**TXDOT AVIATION STATEWIDE AIRFIELD ELECTRICAL CONSTRUCTION PROJECT
GROUP ALPHA**

TXDOT CSJ NO.: 4222AVSAEA RE-BID

RE-BID ADDENDUM NO. 1

September 17, 2025

ET1.3

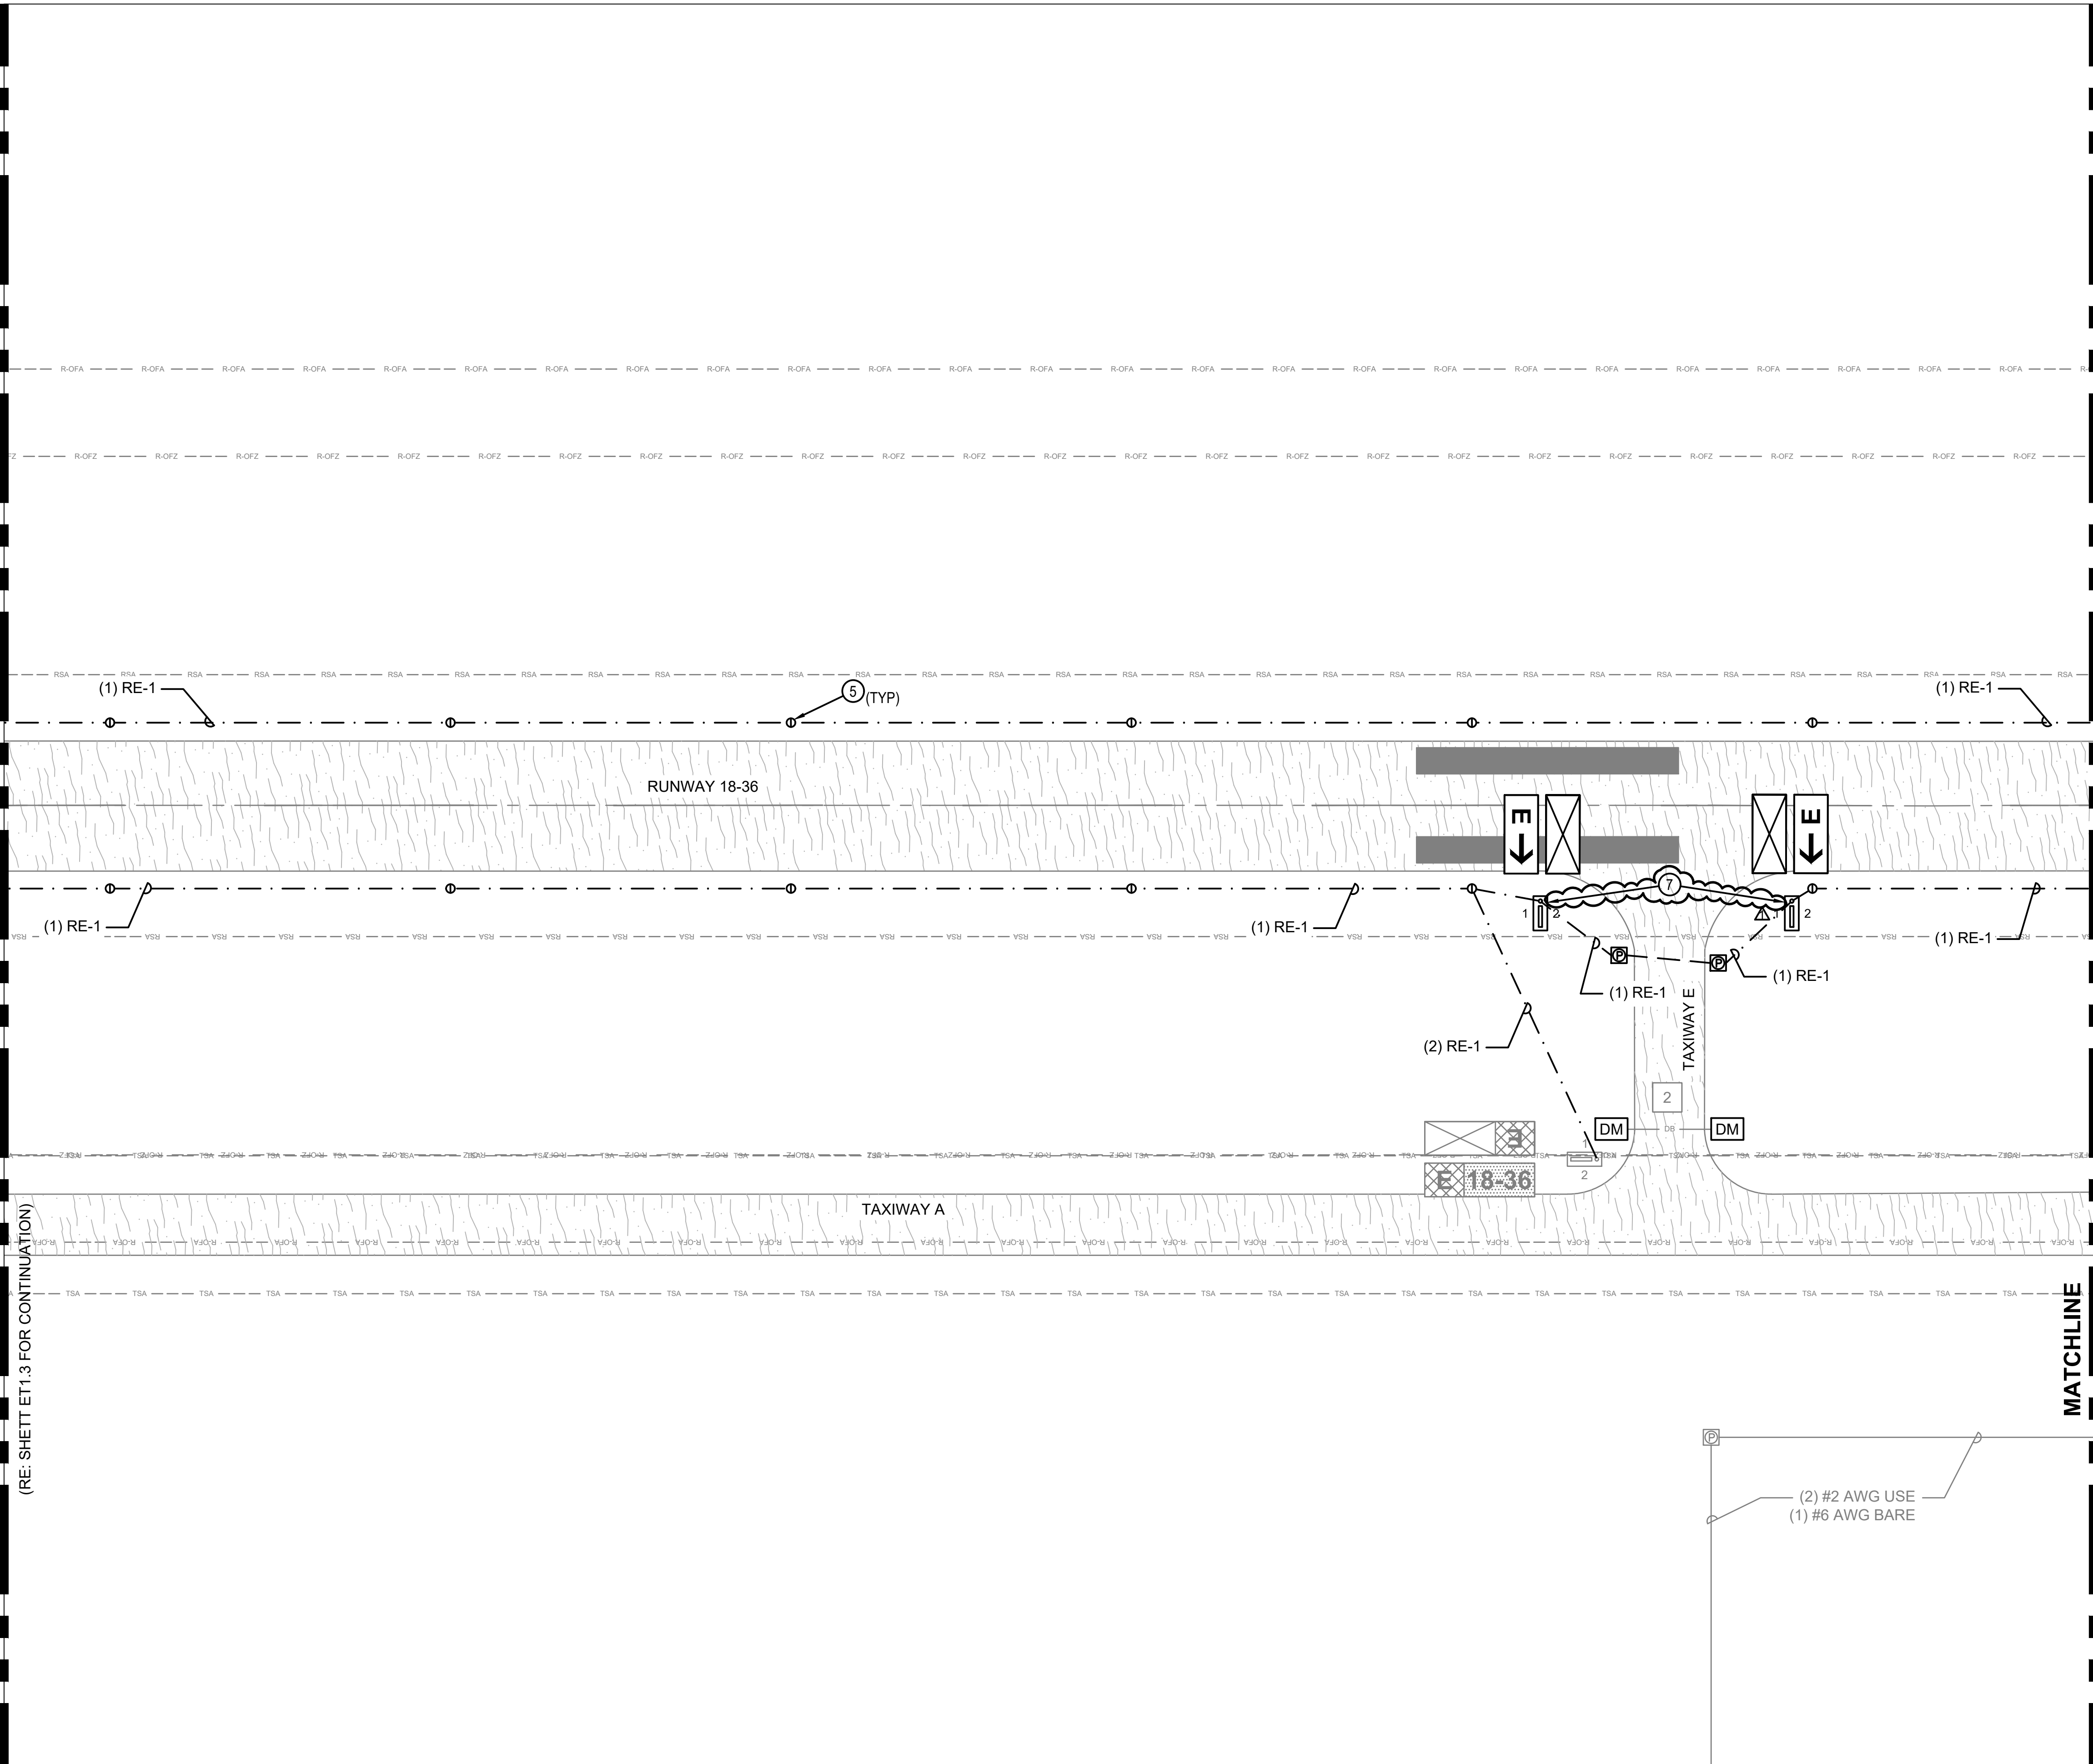
- b) **Directional drill call-outs on sheets ES2.1 and ES2.4 have been updated to reflect the correct quantity of conduits to be installed.**
- c) **Keyed note 7 has been added to sheets ET1.1, ET1.2, ET1.3, ET1.4, and ET1.5 to clarify the airfield guidance sign demolition scope.**

10. For Terrell Airport, pages ET1.1, ET1.2, ET1.3, ET1.4 & ET1.5 have airfield guidance signs to be removed. Please verify if the foundations are to remain or be removed.

RESPONSE: A keyed note has been added to the ET1 series for clarification. See updated plan sheets included in Addendum 1.
